REQUEST FOR INFORMATION	DATE: April 20, 2016	NO.: RFI-046
--------------------------------	-----------------------------	---------------------

Project Name: Webster University Interdisciplinary Science Building Project No.: 15051

Subject: BP 1 Structural concrete clarifications

A0313

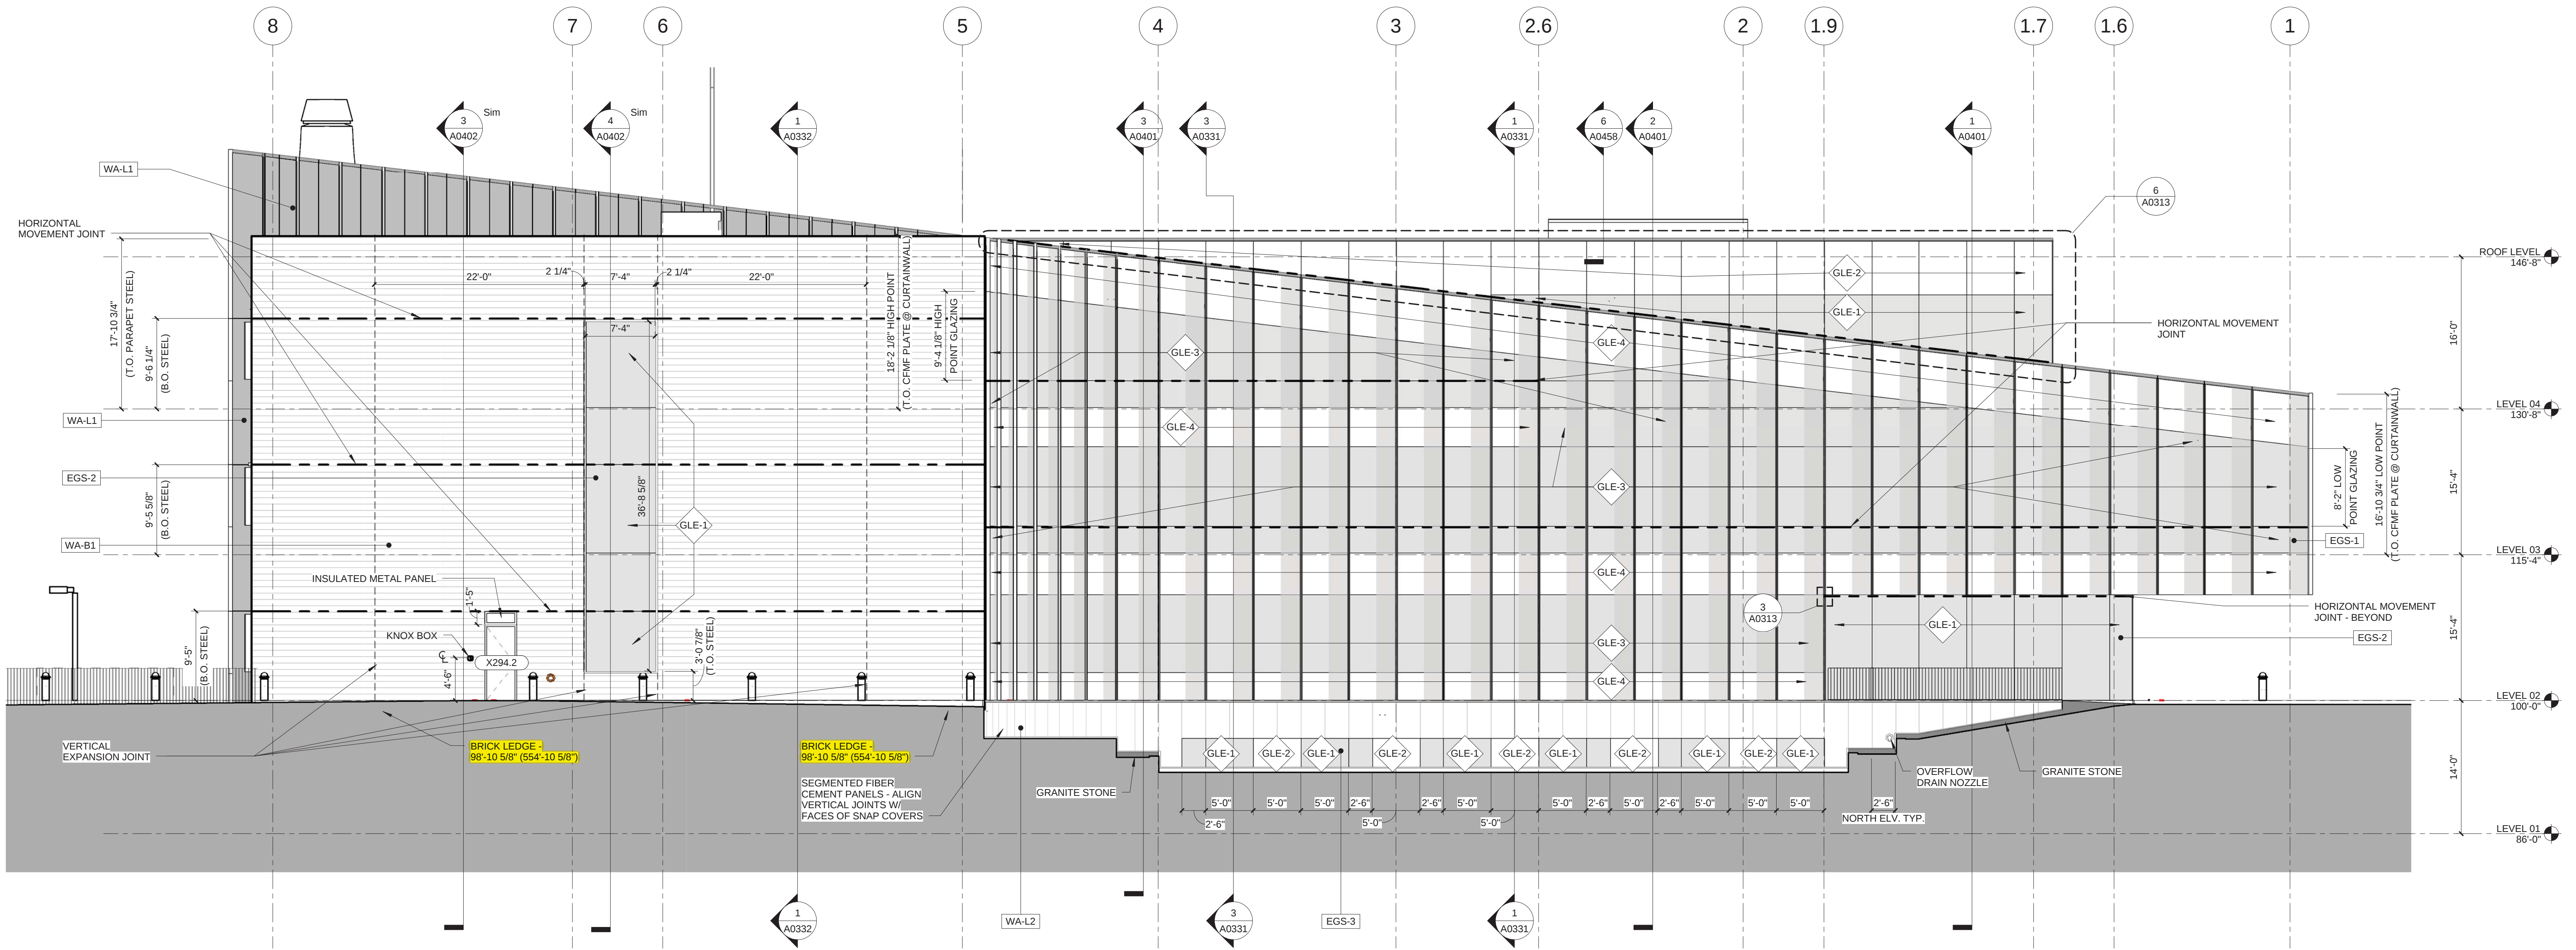
- a. Detail 1/A0312 – South Elevation – Dimensions of Brick Ledges from Gridline “8”
 - b. Detail 1/A0313 – East Elevation – Dimensions of Brick Ledges from Gridline “B”

- c. Detail 1/A0313 – East Elevation – Dimensions of Brick Ledges from Gridline “F”
5. Please confirm both Elevator Pit Hoistway Dimensions are correct as indicated on Contract Drawing S0100:

- 4) Information forthcoming in future addendum based on revised survey.
- 5) General contractor to coordinate with Elevator contractor.
- 6) General contractor to coordinate with Elevator contractor and Plumbing contractor.

1 SOUTH ELEVATION
1/8" = 1'-0"

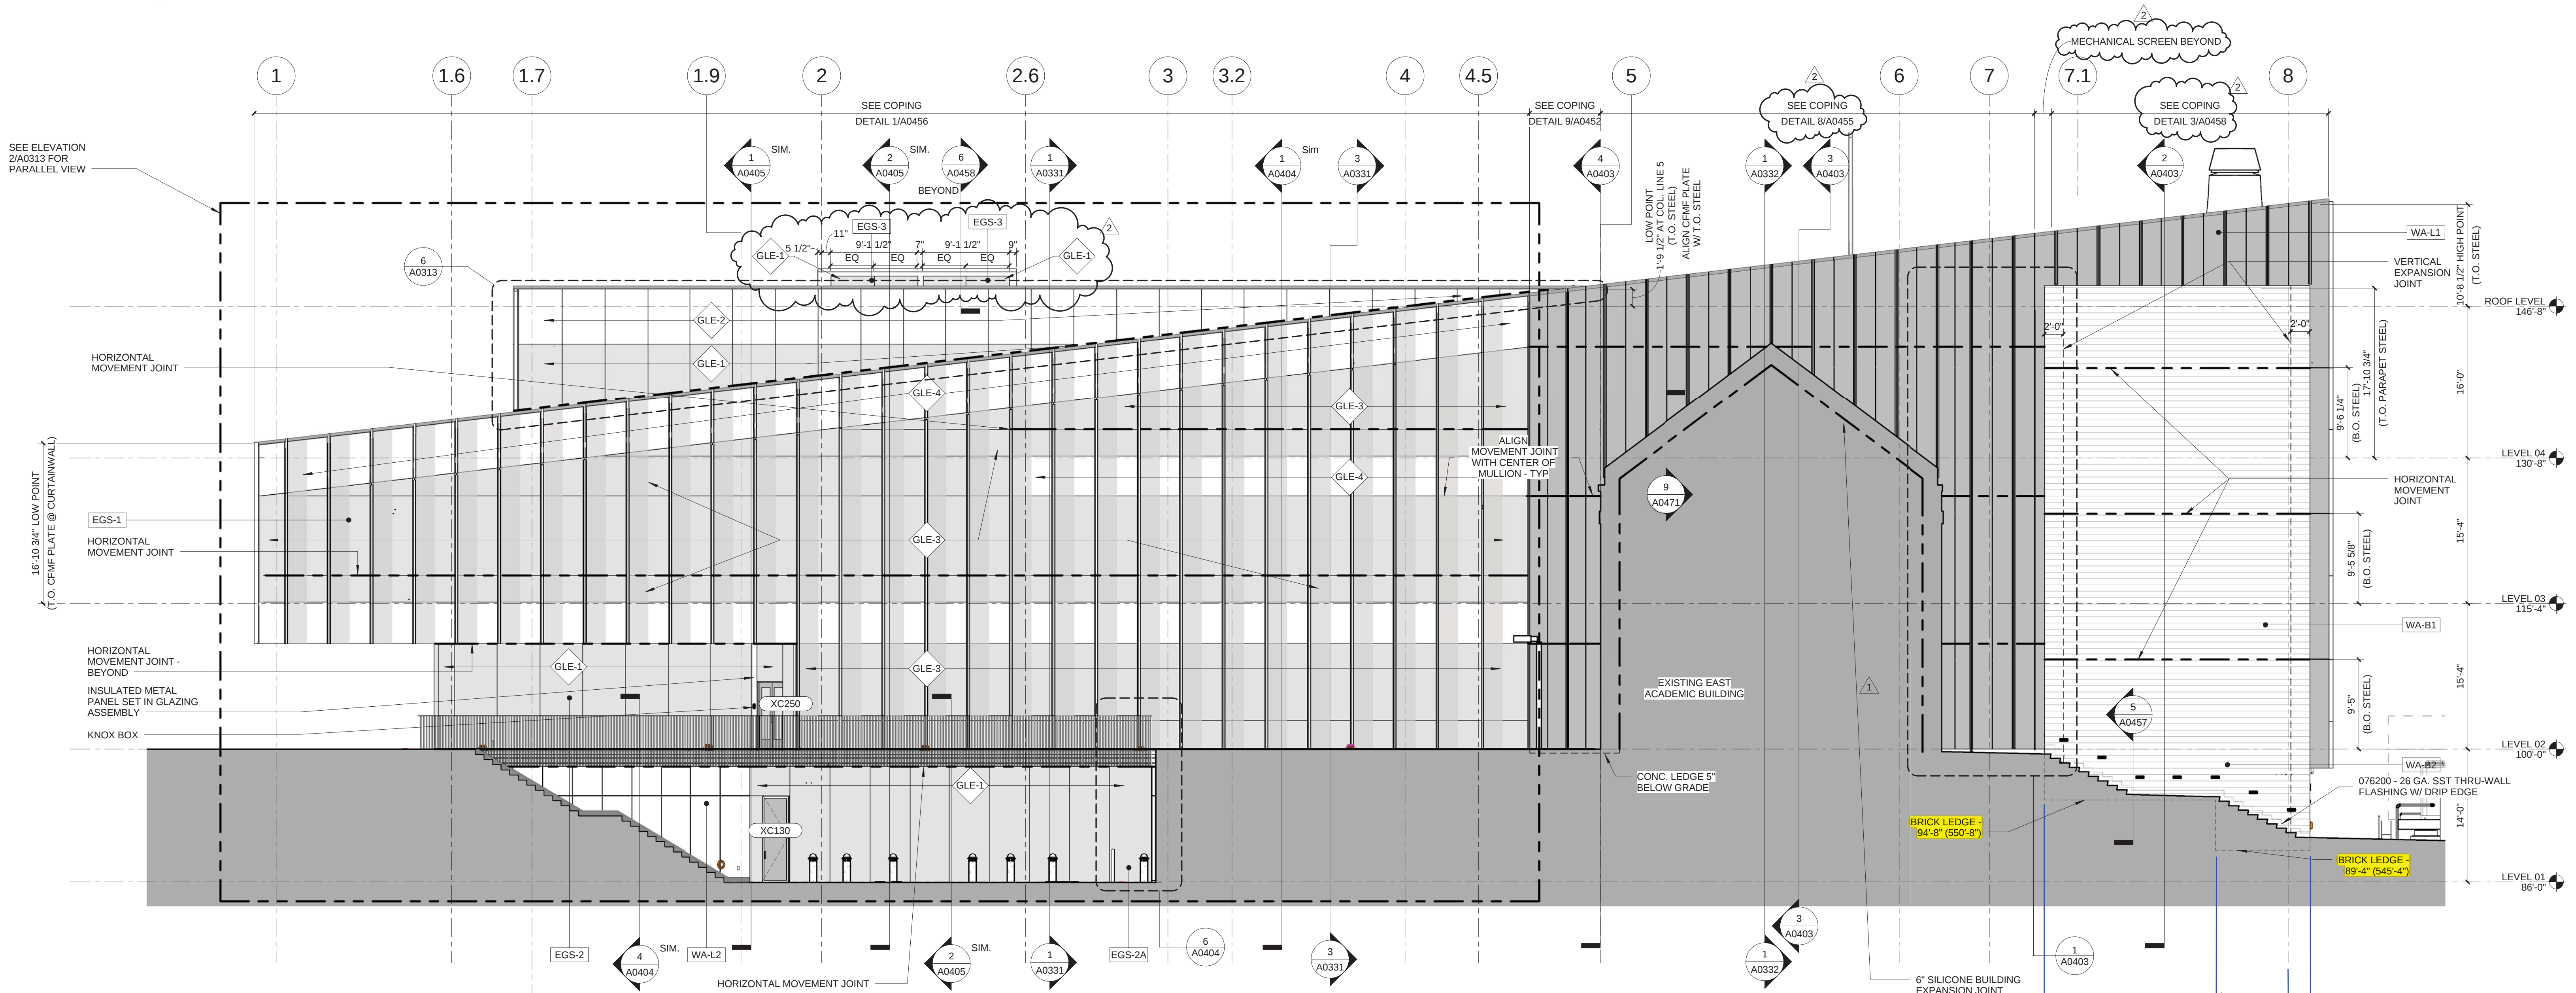
4. On the attached KCI marked up PDF of both Drawing Sheets A0312 and A0313, can you please provide the following Brick Ledge horizontal dimensions as indicated on the attached:
